SERVICE BULLETIN

from: TRIO-KENWOOD COMMUNICATIONS, INC.

SUBJECT: ALTERNATOR WHINE, TR-7600/7625

DATE July 9, 1979

■ PLL UNIT (X50-1580-10)

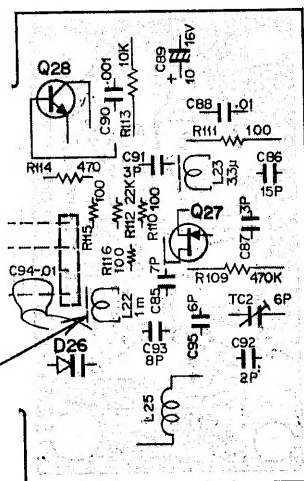
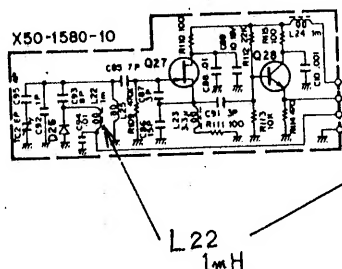
If all of these measures fail, replace L22 on the VCO unit X50-1580-10 from the original green coil, to either an orange or black coil. No adjustments should be necessary.

Old part number L40-1021-03 1mH
New Part number L40-1021-43 1mH
